Our ref: LTR-NRC-08-25

**Subject:** Response to NRC Request for Additional Information on WCAP-16608-P, Addendum 1, "Westinghouse Containment Analysis Methodology, Addendum 1 Appendix C, PWR LOCA Mass and Energy Release Input Calculation Methodology" (Proprietary/Non-Proprietary) dated May, 2008

**Response to NRC Request for Additional Information on  
WCAP-16608-P, ADDENDUM 1 REVISION 0, "WESTINGHOUSE CONTAINMENT ANALYSIS  
METHODOLOGY, ADDENDUM 1, APPENDIX C, PWR [PRESSURIZED WATER REACTOR]  
LOCA [LOSS-OF-COOLANT ACCIDENT] MASS AND ENERGY RELEASE INPUT  
CALCULATION METHODOLOGY"**

REQUEST FOR ADDITIONAL INFORMATION (RAI)  
BY THE OFFICE OF NUCLEAR REACTOR REGULATION  
WCAP-16608-P, ADDENDUM 1, REVISION 0, "WESTINGHOUSE CONTAINMENT ANALYSIS  
METHODOLOGY, ADDENDUM 1, APPENDIX C, PWR [PRESSURIZED WATER REACTOR]  
LOCA [LOSS-OF-COOLANT ACCIDENT] MASS AND ENERGY RELEASE INPUT  
CALCULATION METHODOLOGY"  
WESTINGHOUSE ELECTRIC COMPANY  
PROJECT NO. 700

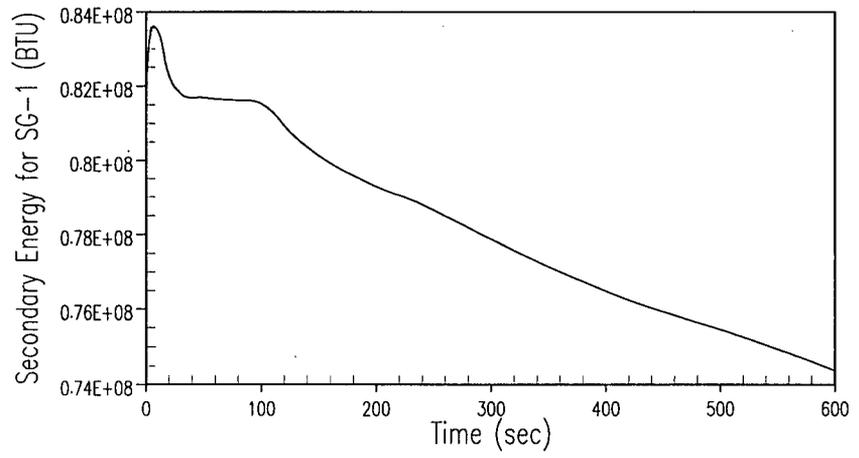
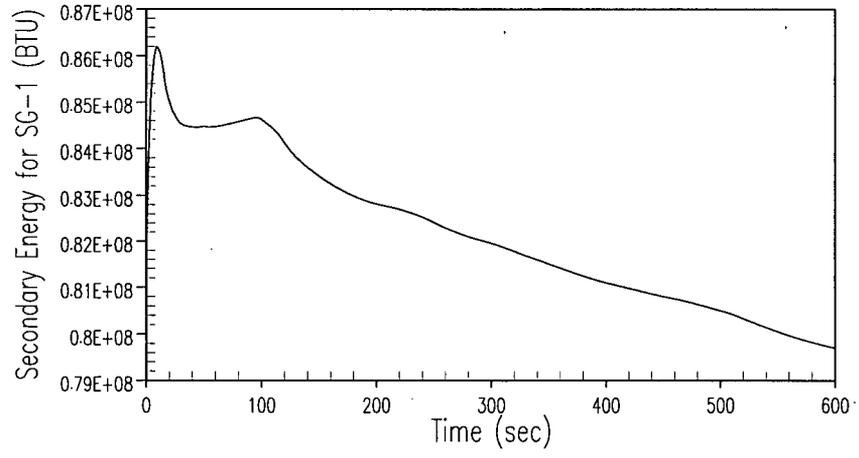
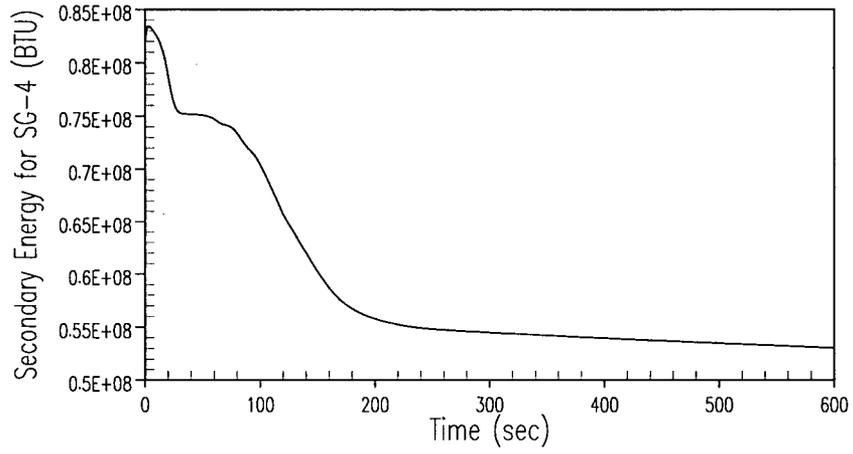
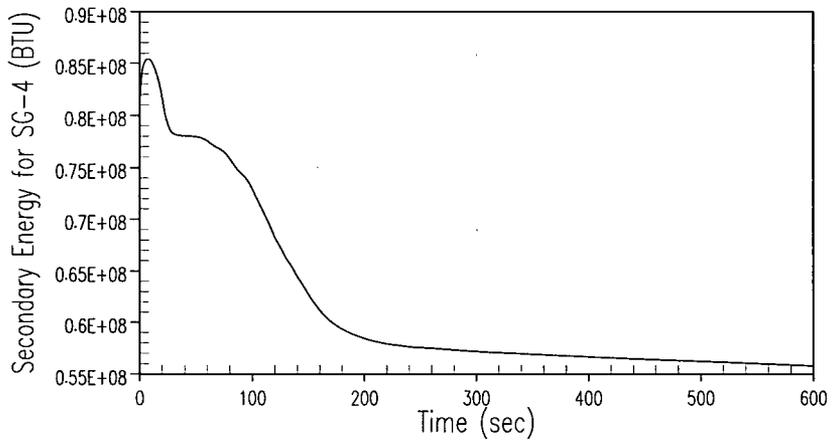
10. Table C.3-2, Item 9: Please confirm that an evaluation was performed to verify that M&E added due to feedwater flow from the event initiation to feedwater isolation has no effect on the containment response.

*Westinghouse Response: A loss of offsite power is assumed at the start of a LOCA event. The loss of offsite power causes the feedwater pumps to trip and the flow rate to coast down. An SI signal causes the feedwater control valve to start to close. The SI signal is generated fairly quickly in a large LOCA event. Therefore, following the design basis large LOCA event, the main feedwater flow would continue for only a short period of time. This time would depend on how long it takes for the pumped flow rate to coast down and the flow control valve to close.*

*A sensitivity case was run during the initial WC/T LOCA M&E model development program to examine the containment response to modeling the feedwater flow coast down. WC/T uses the feedwater velocity as input to the feedwater FILL component. For the sensitivity case, the feedwater FILL velocity was ramped from 19.5 ft/s to 0.0 ft/s over the first 10 seconds of the transient. This added approximately  $1100 \times 5 = 5500$  lbm of water and approximately  $5500 \times 450 = 2.5$  MBTU of energy to each steam generator. This represents about 2% of the total energy in each steam generator.*

*The transient fluid energy plots for an intact loop SG and the broken loop SG are shown in Figures 1 through 4. Both the intact loop and broken loop SG energy increase by approximately 1.5 MBTU shortly after trip in the base case (Figures 1 and 3). The SG energy for the sensitivity case increases by approximately 4 MBTU shortly after trip (Figures 2 and 4). As expected, this is about 2.5 MBTU higher for each SG than the base case. At the end of the transient, the total fluid energy remaining in the sensitivity case steam generators is about 18 MBTU greater than the base case steam generators. Therefore, the sensitivity case steam generators are cooling down slower than the base case steam generators.*

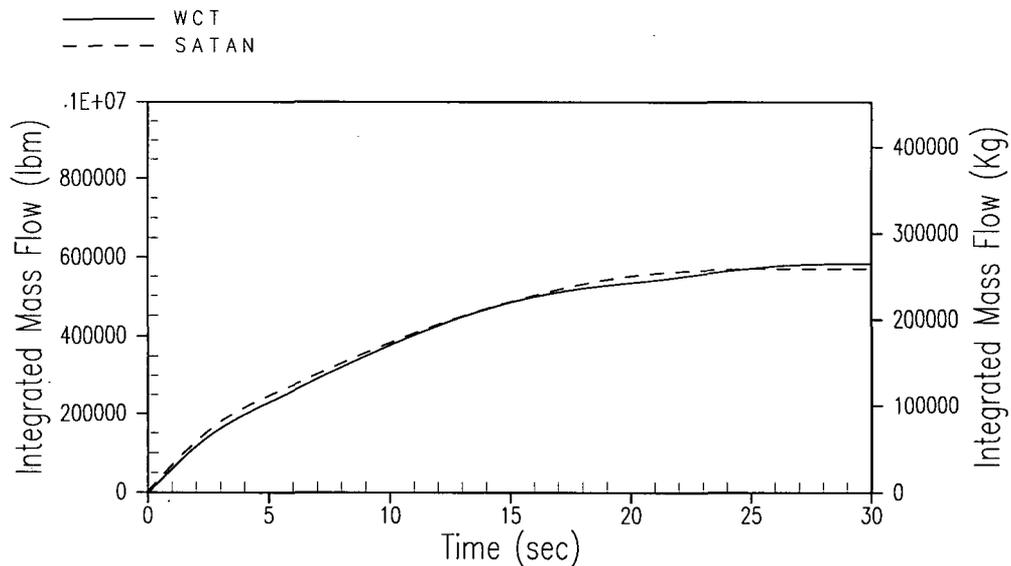
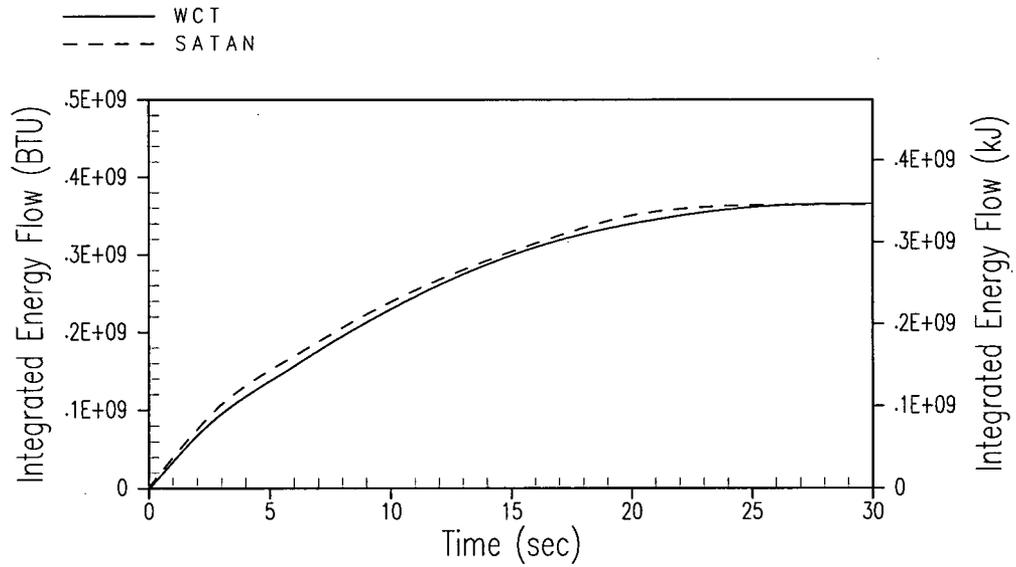
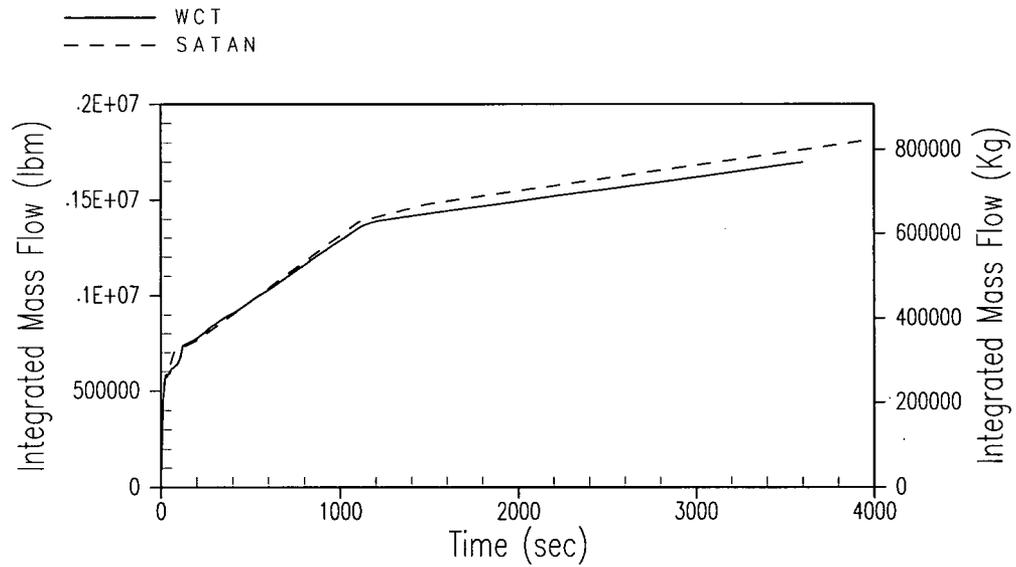
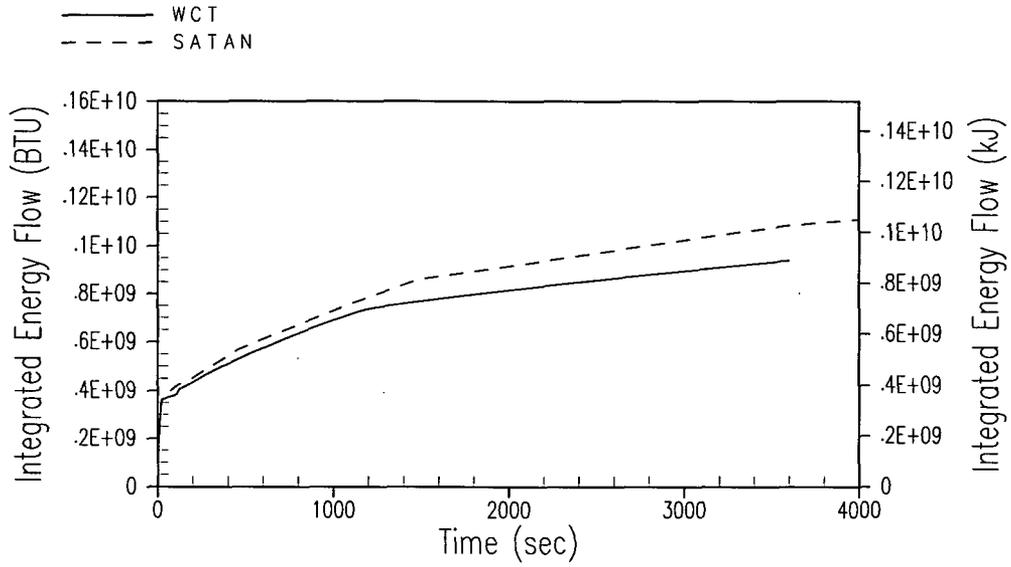
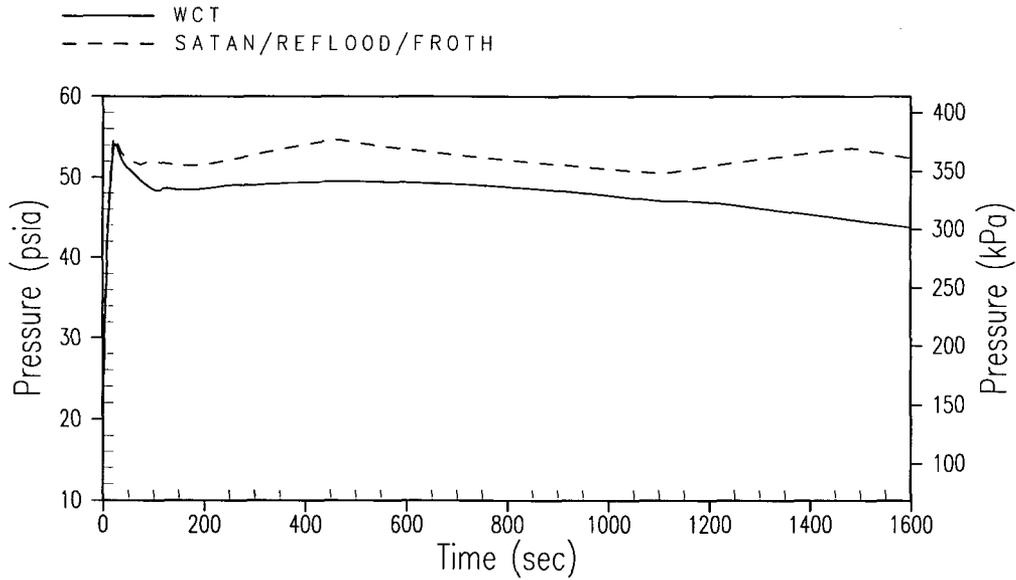
21. The comparisons of the proposed revised WC/T results to the currently approved methods do not show the impact of the changes within WC/T. Regarding section C.4.3, provide the same plots with the addition of calculations from the unmodified version of WC/T (without the code updates). Include additional results to show the quench behavior at a few selected locations, and discuss the results comparing the modified WC/T model to the unmodified model for steam generator heat transfer.

*Westinghouse Response: A comparison of the LOCA mass and energy release results from the unmodified WC/T code with WCAP-10325 results was not included in the topical report; however, this was done as part of a feasibility assessment. The results were documented internally and presented in a paper that was published as part of the ICONE14 conference proceedings (ICONE14-89258). The unmodified WC/T RCS model does not include the improved SG noding structure, SG secondary metal, the interfacial heat and mass transfer model, or run in parallel with the GOTHIC containment model.*

*The LOCA ECCS evaluation model input deck for a Westinghouse 4-loop, 3600 MWth PWR was used to test the feasibility of using WC/T for LOCA M&E calculations. The LOCA ECCS evaluation model input was biased to generate bounding LOCA M&E release data for the containment model. The system volume was increased to account for measurement uncertainty and thermal expansion. The WC/T STGEN component did not include metal, so the SG secondary water volume was increased to account for the SG secondary metal stored energy and uncertainty in the secondary volume. Additional RCS pipe volumes were*

incorporated in the WC/T ECCS evaluation model to include the metal in the SG inlet and outlet plenums. The initial core thermal power, RCS pressure, and RCS temperatures were also increased to include uncertainties. After making these changes, a steady state restart point was created. The initial WC/T model mass and energy was compared with the benchmark LOCA M&E release model mass and energy on a component by component basis to verify the model initial conditions were equivalent before running the transient benchmark comparisons.

The mass and energy release output from the biased WC/T models was compared with the current LOCA M&E release model output for a double ended pump suction LOCA event. The integrated blowdown mass and energy release comparison for the 4-loop plant model is shown in Figures 8 and 9. The biased WC/T model calculated approximately the same blowdown break mass and energy release. The integrated long-term mass and energy release comparison is shown in Figure 10 and 11; the biased WC/T model calculated a lower long-term energy release. An investigation identified the cause of the difference. The calculated SG heat transfer in the biased WC/T model was lower than the non-mechanistic SG heat release from the current LOCA M&E release model; the WC/T SG model was cooling down from the bottom up and the secondary fluid had become stratified.

The mass and energy releases were fed into the corresponding GOTHIC containment model to determine the impact on the containment pressure. As can be seen in Figure 12, the blowdown peak pressure is the same, but because the biased WC/T long-term energy release is lower, the long-term peak containment pressure is at least 5 psi lower than that predicted using the current LOCA M&E release model.
